Planning Commission Hearing Date: March 4, 2025
Board of Commissioners Hearing Date: March 27, 2025

STAFF ANALYSIS

Case No.:	Z-25-1247356	File ID #: 2025-0045
Address:	2883 & 2893 Midway Road	Commission District: 03 Super District: 06
Parcel ID(s):	15-201-12-002 & 15-201-12-003	
Request:	Rezone property from R-75 (Residential Medium Lot-75) Zoning District to R-60 (Residential Small Lot-60) Zoning District to develop a cottage court community.	
Property Owner(s):	Jeffrey Robertson and Carla Langan	
Applicant/Agent:	Microlife Institute	
Acreage:	2.12 acres	
Existing Land Use:	Single Family Residence and Vacant Lot	
Surrounding Properties:	North: R-75 (Residential Medium Lot-75) East: R-75 South: C-1 (Local commercial), C-2 (General Commercial) West: R-75	
Comprehensive Plan:	SUB (Suburban) Inconsistent	Consistent X

Staff Recommendation: Approval with Conditions.

PROPOSED SITE PLAN
2883 & 2893 MIDWAY RD

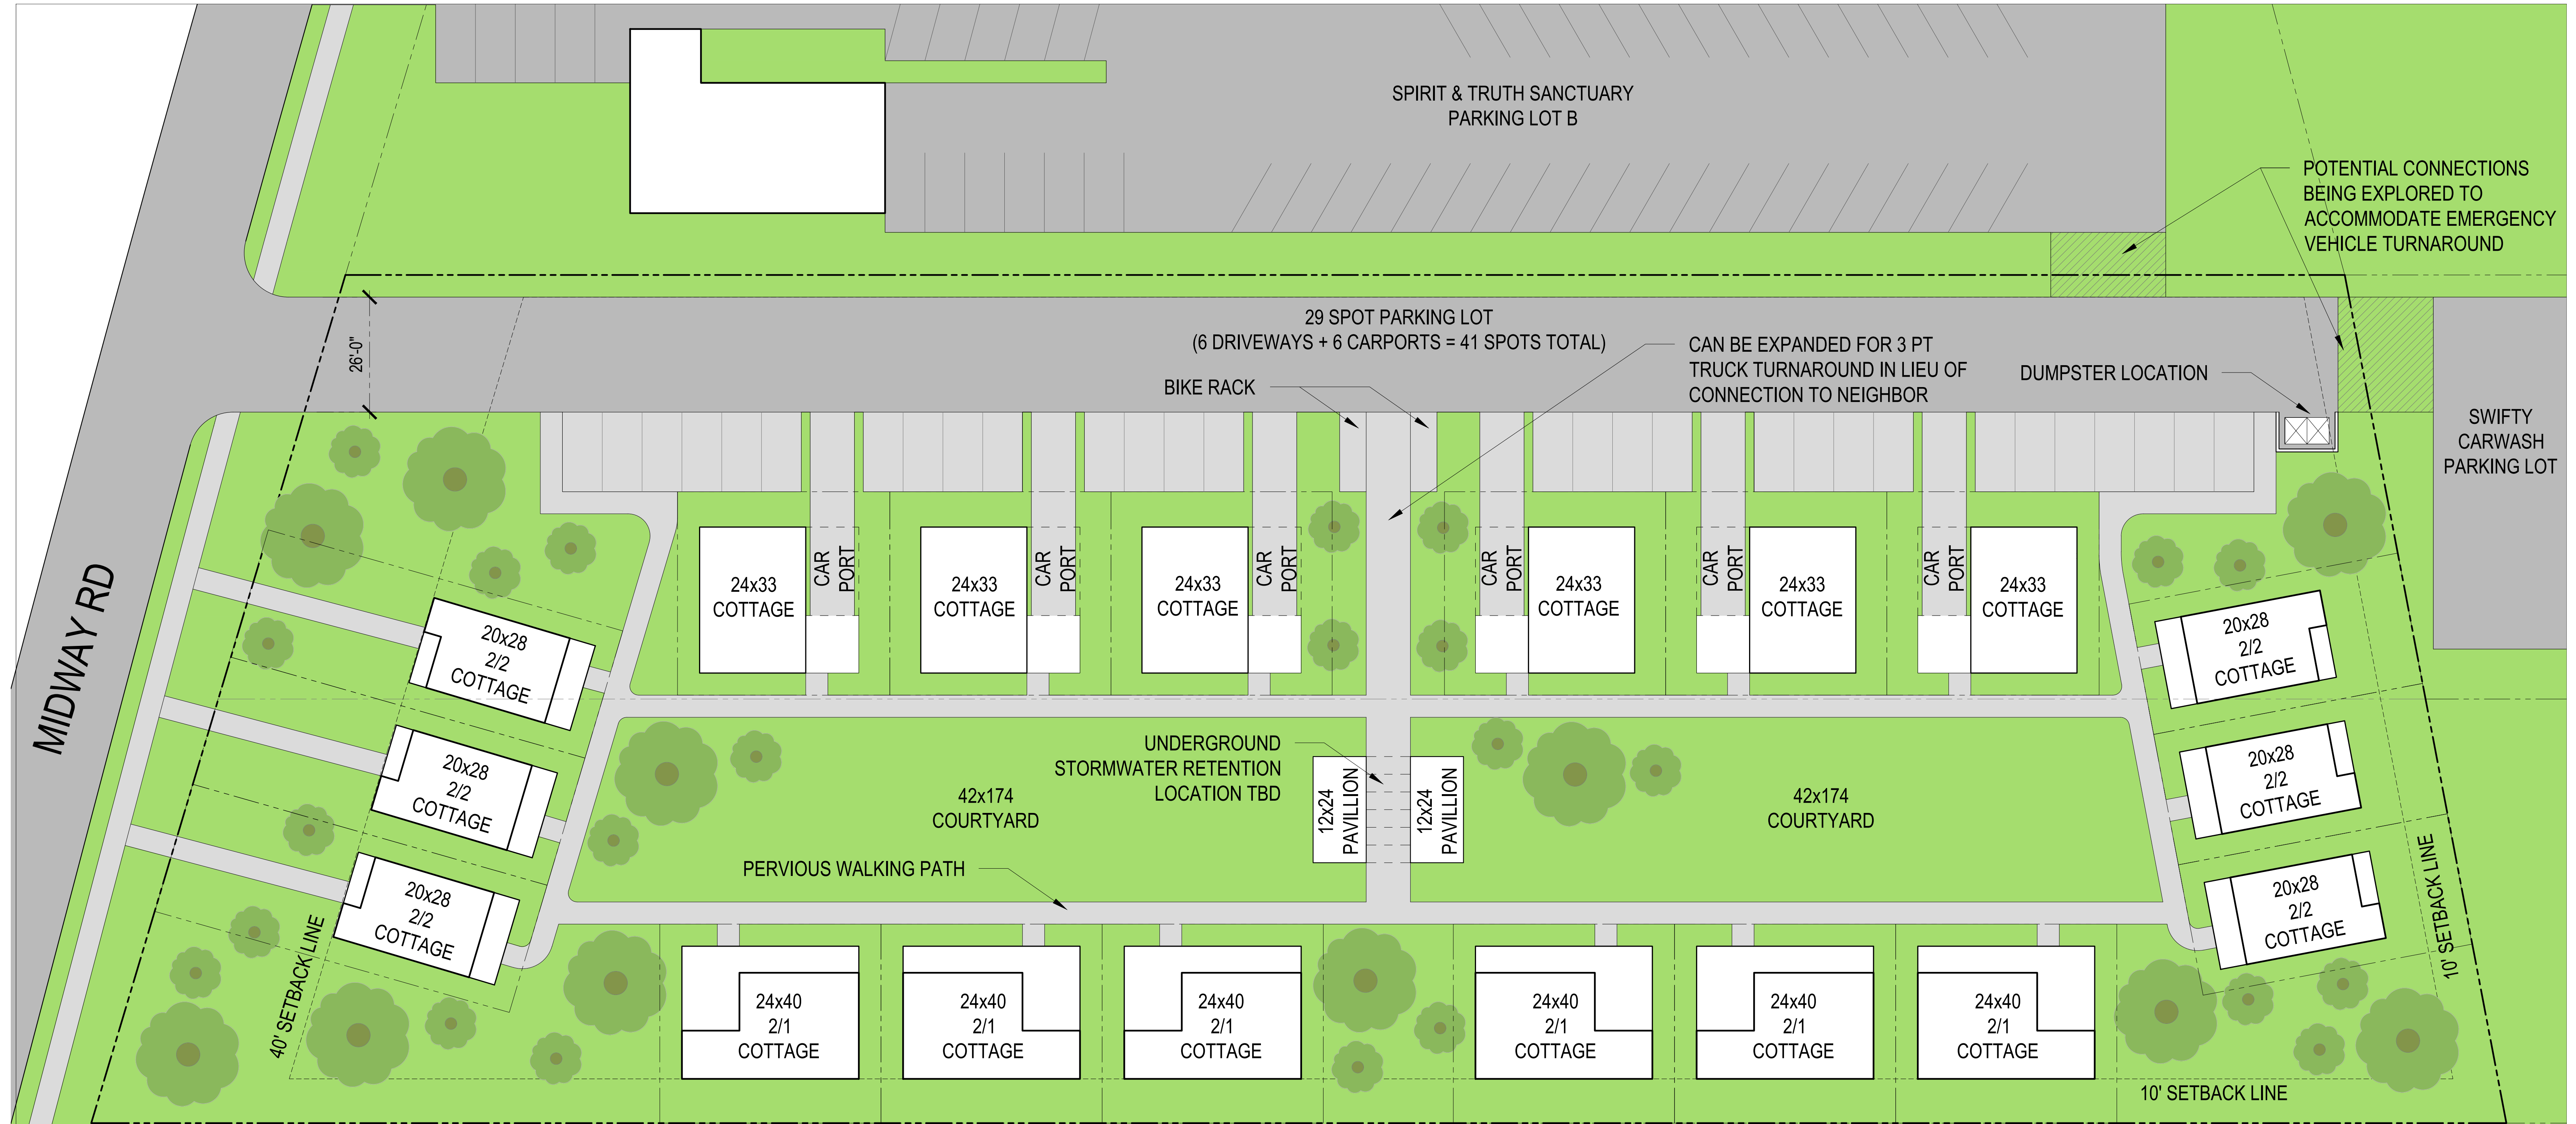
Additionally, the Applicant will need to address the following items from 27-5.7.9 in Site Plan *Version 1*:

(D1.) Separation distance between buildings shall be no less than ten (10) feet. However, this distance may be decreased to six (6) feet if the enhanced open space is increased by an equivalent or greater amount.

(D2) Show the maximum lot coverage for the total cottage development does exceed sixty (60) percent and that twenty (20) percent of the total site area shall be reserved for open space. Dwelling units oriented toward the common open space area shall provide a five-foot minimum setback from the common area.

(F) Off-street parking shall be located no more than two hundred (200) feet from a unit's entrance. The Applicant will need to demonstrate the site plan meets this requirement.

Chapter 27-6.1.4 Off Street Parking Ratios states single-family cottage dwellings shall consist of two (2) spaces per dwelling unit, plus one-quarter (0.25) space per dwelling unit to accommodate guest parking. This would amount to forty (40) spaces maximum. As proposed, the development contains twenty-nine (29) off-street parking spaces, six (6) driveways, and six (6) carports totaling forty-one (41) total parking spaces. The Applicant will need to decrease the parking by one (1) space or apply for a variance from the Zoning Board of Appeals (ZBOA). Furthermore, the Applicant will need to verify the proposal complies with 27-5.7.9 (*J Additional Cottage Development Elements*). Other interdepartmental comments (enclosed) to be considered:

PROPOSED COTTAGE PLANS/ELEVATIONS
2883 & 2893 MIDWAY RD
DECATUR, GA 30030

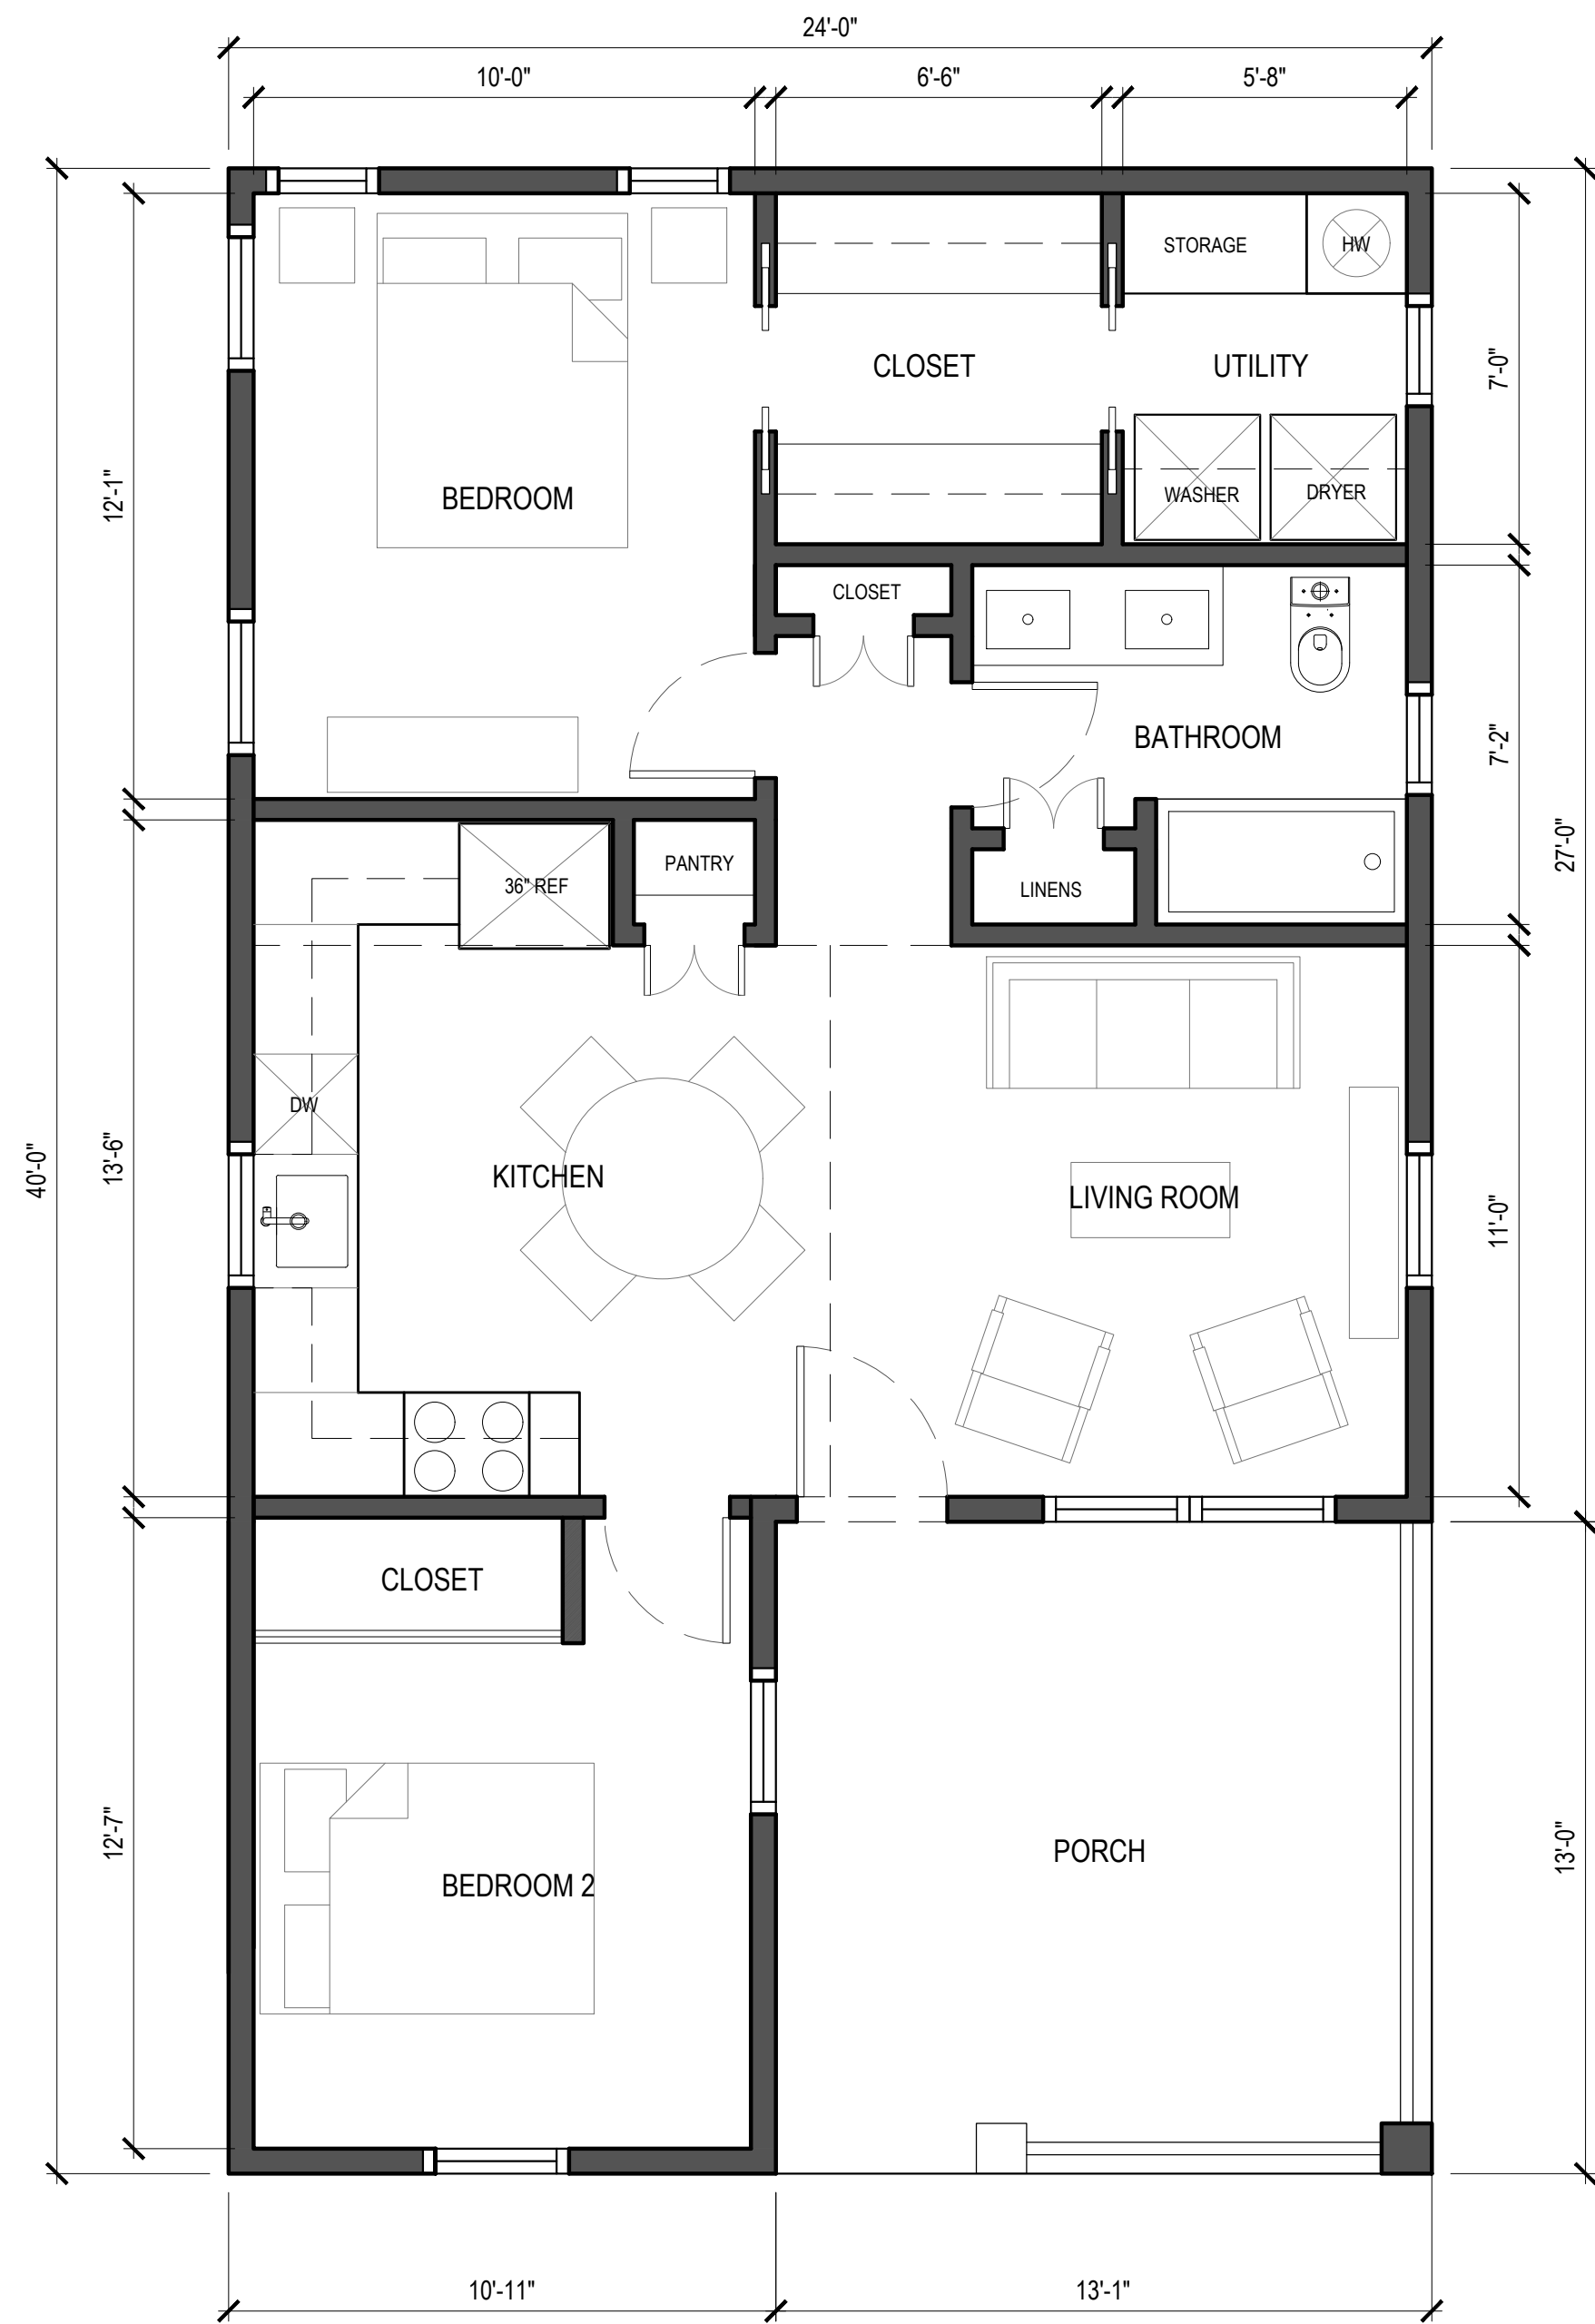
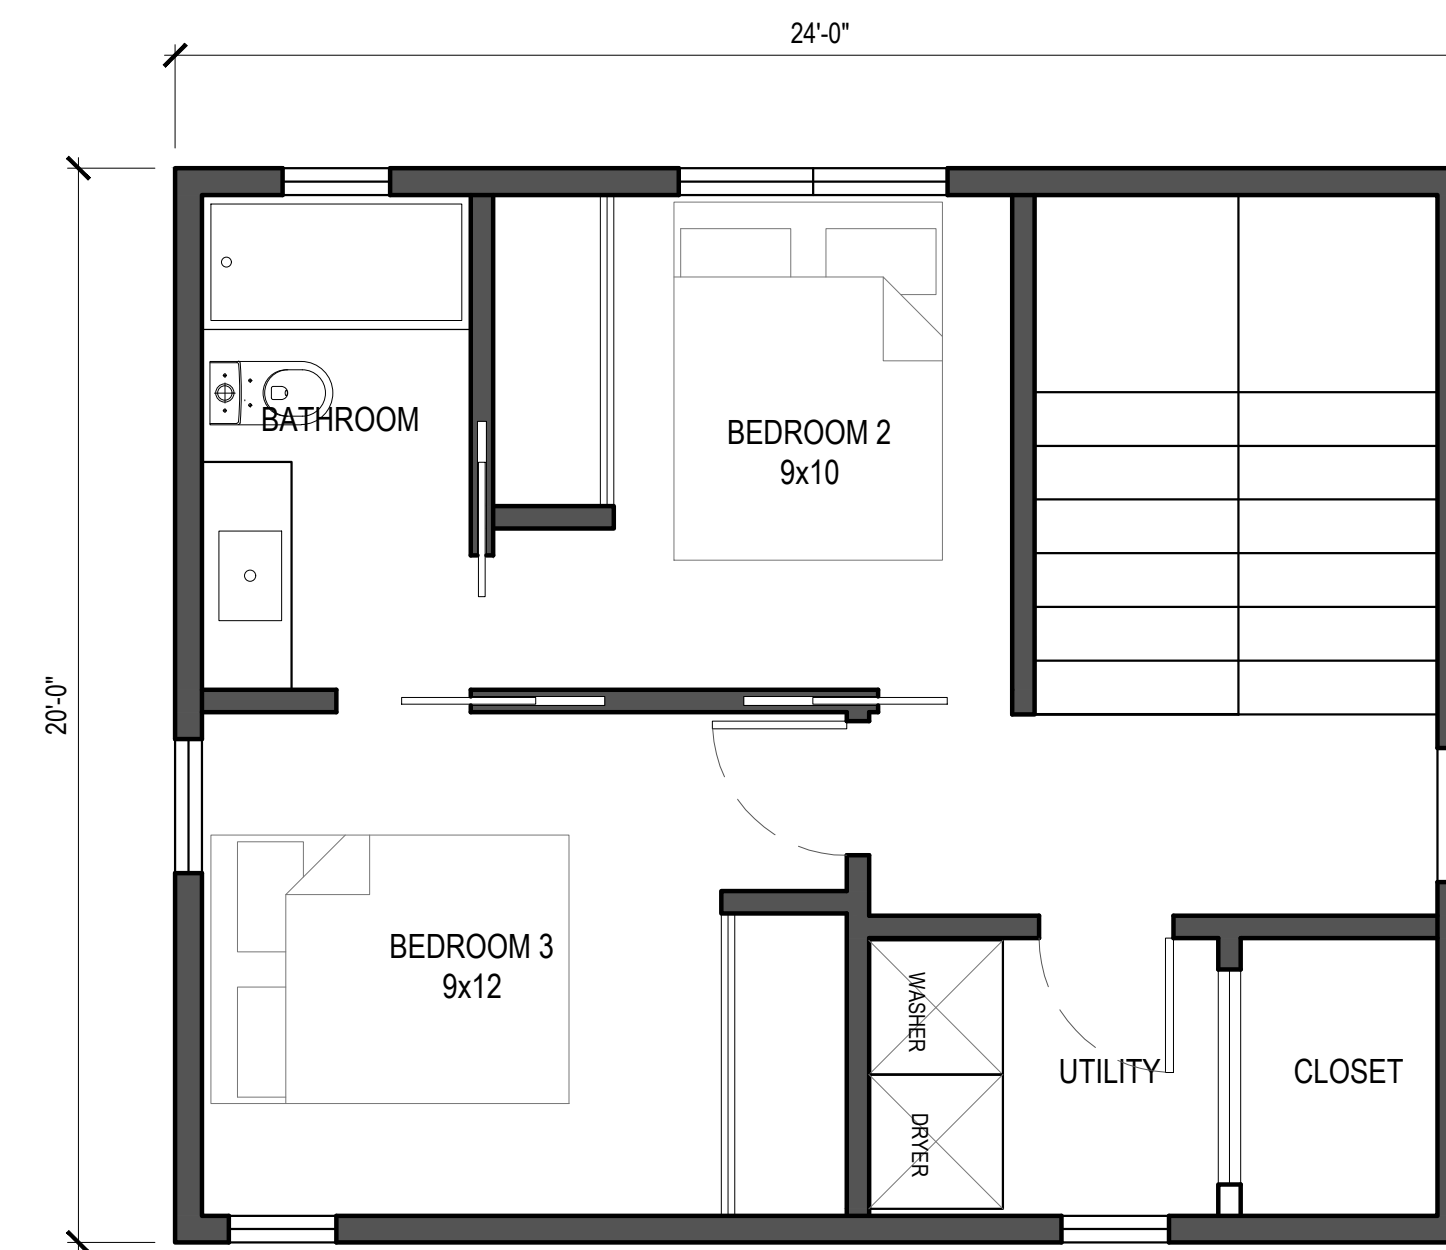
- 5) All home designs shall be consistent with the enclosed color rendering(s) entitled “2883 and 2893 Midway Road Proposed Plans/Elevations and Renderings” dated 12/16/2024, including, but not limited to architectural details and the following building materials: cementitious siding, vinyl windows, shingle roofing or metal roofs over porches, stained cedar plank for post beams and gable crosses, and vinyl garage doors, and must comply with the applicable provisions of Article 5 *Section 5.7.9.* of the Zoning Ordinance related to building form and design.
